Subject: Response to Comments – Letters Dated October 10, 2007 and October 15, 2007
Plainwell Mill, Operable Unit No. 7, Allied Paper, Inc./Portage Creek/Kalamazoo River Site
Plainwell Mill Banks Emergency Action Design Report

Comment Letter Dated October 10, 2007

PROJECT: WEYERHAEUSER COMPANY KALAMAZOO RIVER SUPERFUND SITE			
SHEET TITLE: PROPOSED SEDIMENT CONTAINMENT AREA (PROPOSED GRADES)			
DRAWN BY: WEBER N	SCALE: AS NOTED	PROJ. NO.: 00-05130.03	
CHECKED BY:		FILE NO.: 51300304.mxd	
APPROVED BY:	DATE PRINTED: 10/8/07	FIGURE E-1	
DATE: OCTOBER 2007

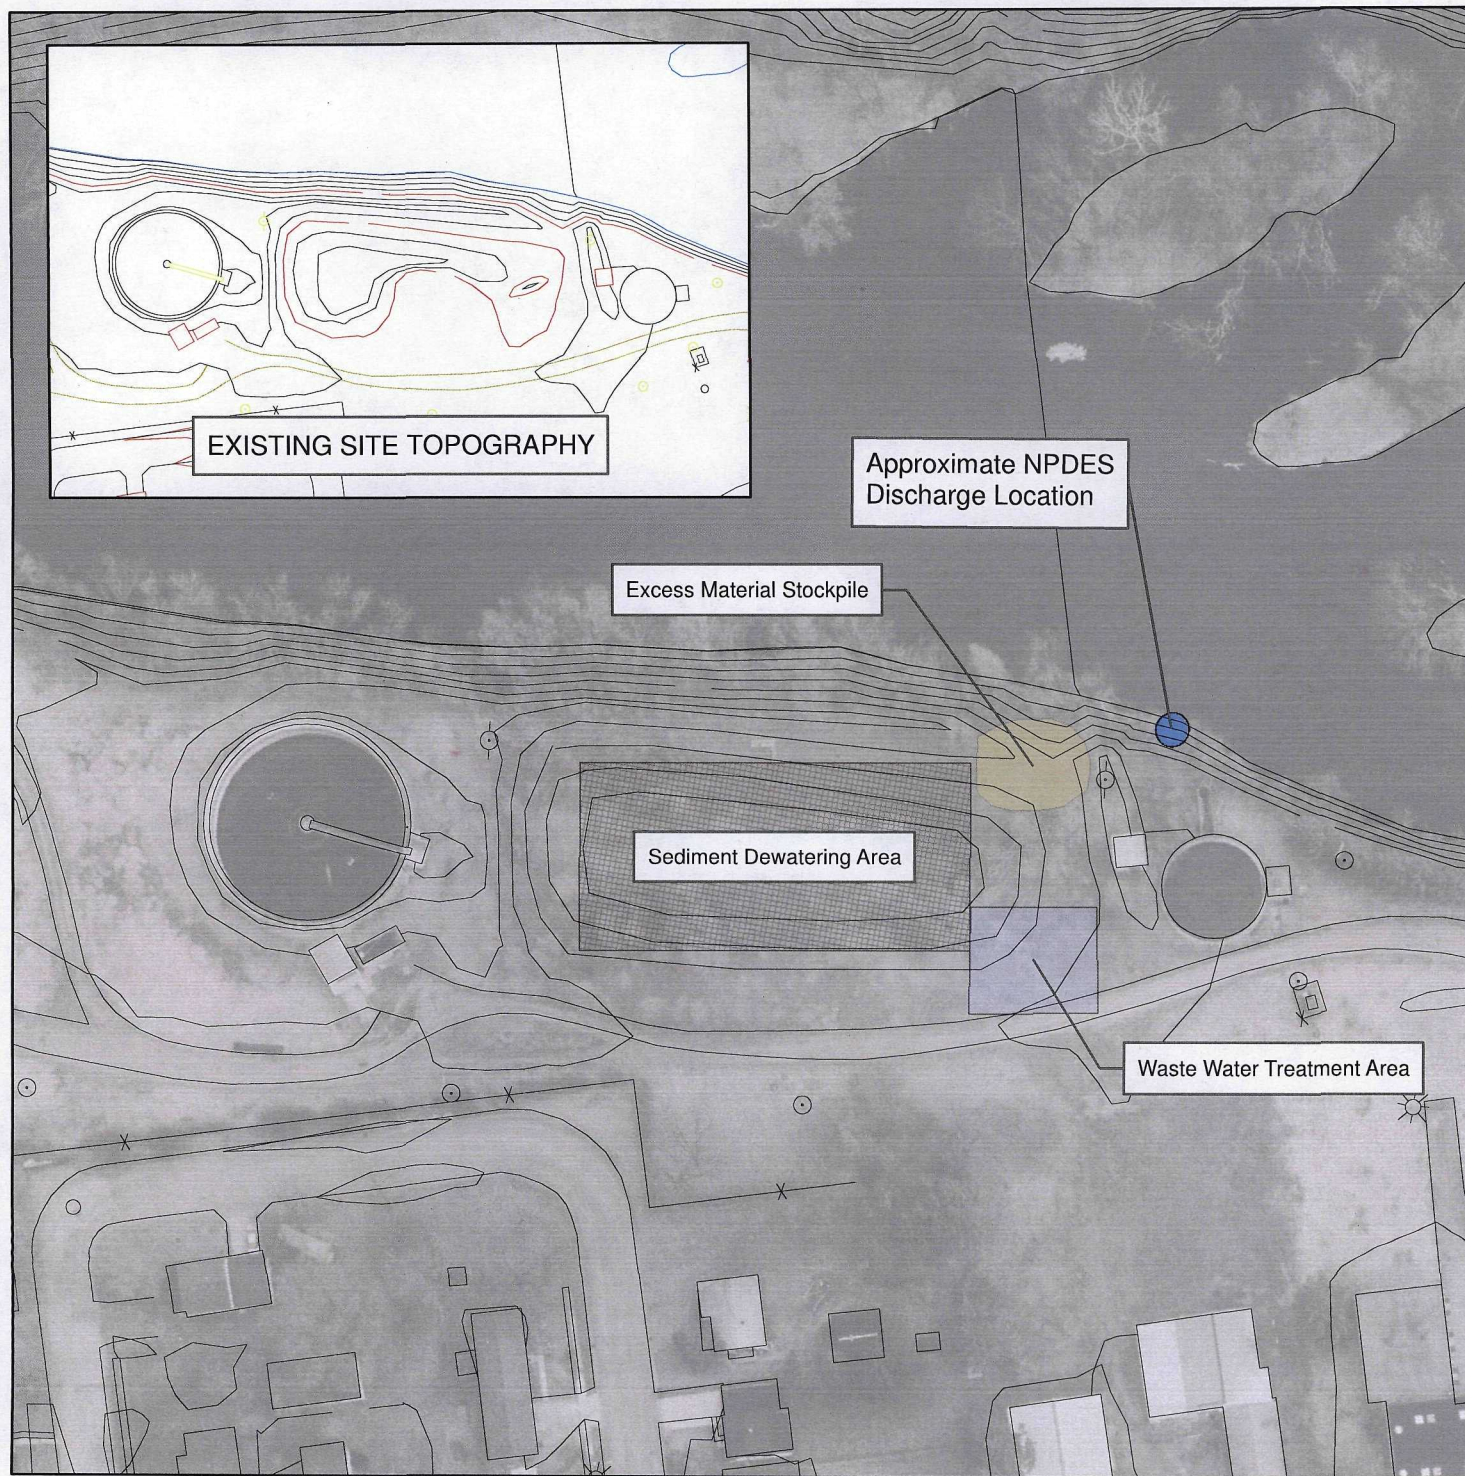
18. Table 3 - Under the wastewater treatment system discharge monitoring section, flow row, which outfall is being referenced by "Effluent to Outfall 001?" Also, the Total Phosphorus being monitored does not have monthly or daily maximum concentrations in the NPDES permit application (Appendix E).

The outfall locator map from the NPDES is attached, the general location is included in attached Figure E-1. For Phosphorus, all that is required is to "report" the concentration of the monthly grab sample. Phosphorus is a constituent that the water division wants periodically monitored. However, phosphorus is not a contaminant of concern based on our analysis so we aren't required to have information about phosphorus in our NPDES equivalency application.

PROJECT: WEYERHAEUSER COMPANY PLAINWELL MILL BANKS EMERGENCY ACTION			
SHEET TITLE: STORM WATER AND PROCESS WATER OUTFALLS			
DRAWN BY: PYLKASE	SCALE: AS NOTED	PROJ. NO.: 00-05130.02	
CHECKED BY:		FILE NO.: 51300202	
APPROVED BY:	DATE PRINTED: 10/16/2007	FIGURE C-1	
DATE: OCTOBER 2007	DRAFT FINAL

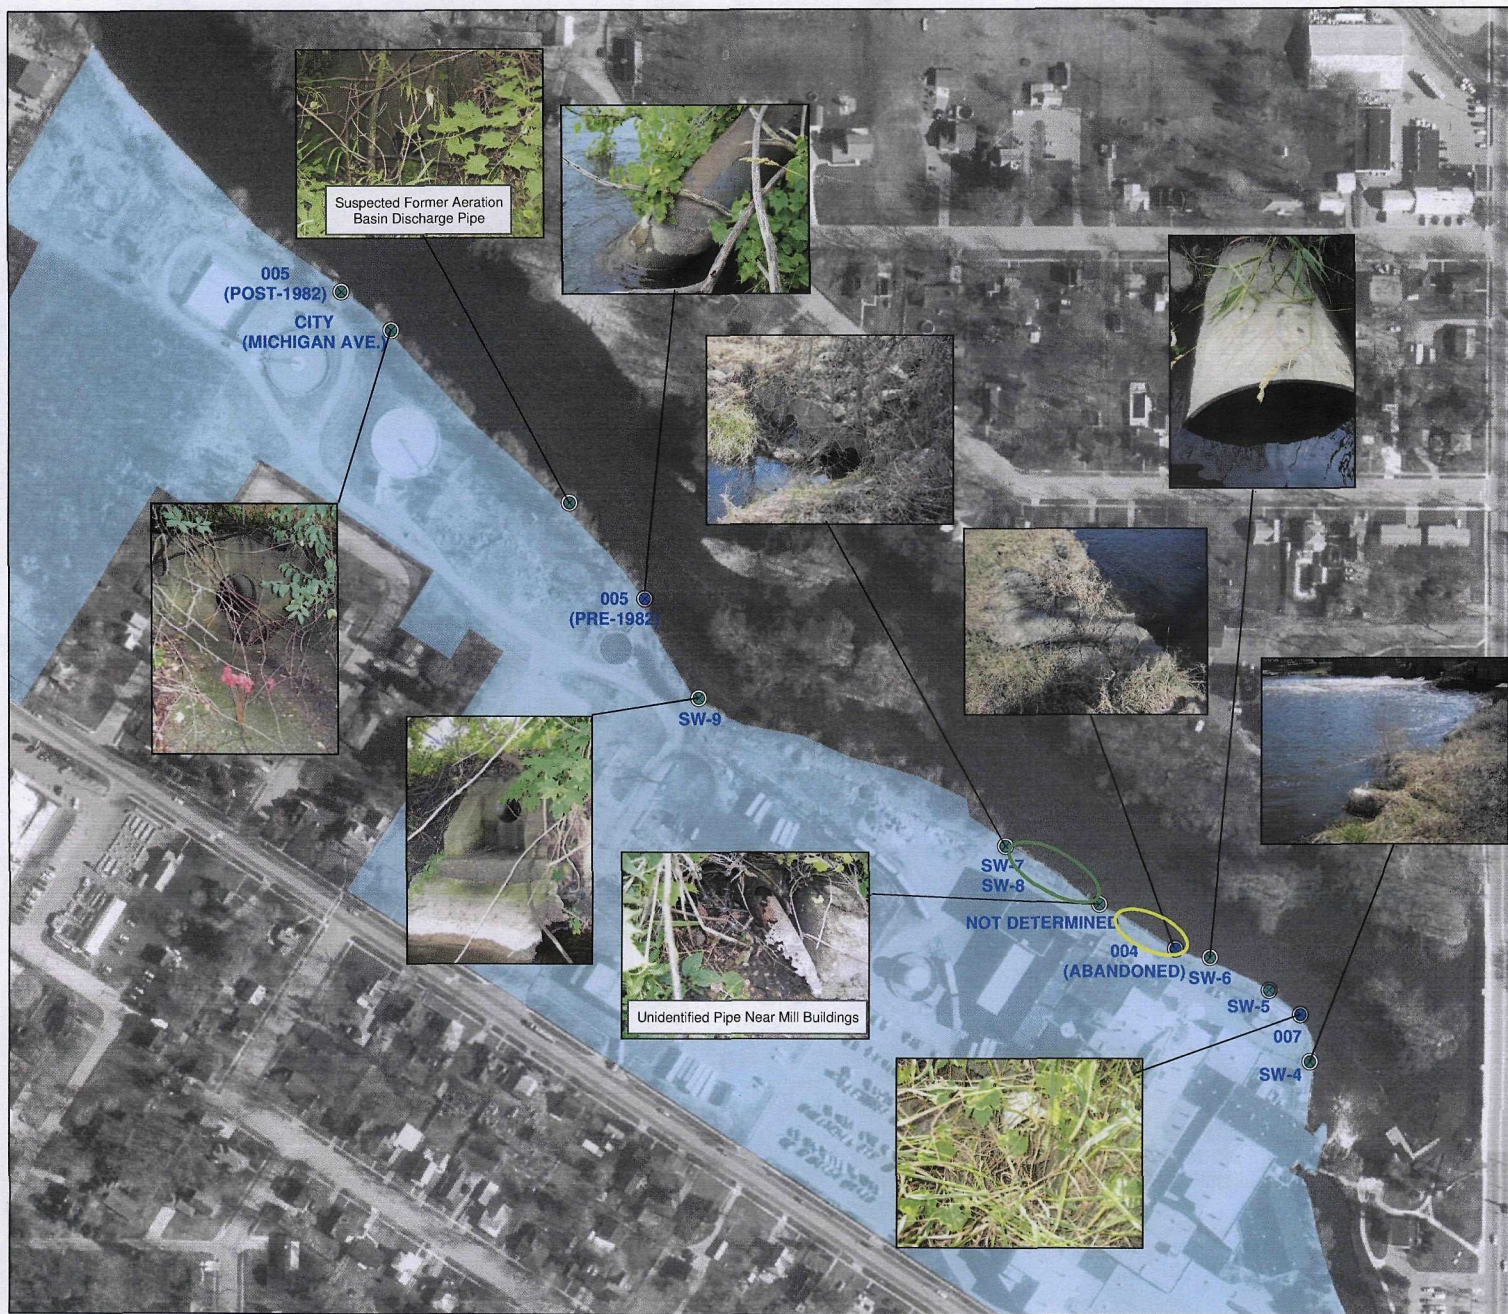
30. Page C-3, Bullets at bottom of page - Outfalls listed here are not identified in Figure C-1. Please identify them in Figure C-1.

31. Table C-1, Outfalls "Aeration Basin" and "Unidentified Pipe" are not identified in Figure C-1. Please identify them in Figure C-1

32. Table C-2 - These outfalls are not identified in Figure C-1. Please identify their locations in Figure C-1.

Figure C-1, attached, has been revised to add labels that identify the unidentified and former aeration basin outfalls.

Figure C-1 has also been revised to label the aeration basin and unidentified pipe.

The approximate location of the unknown outfalls has been added to Figure C-1.
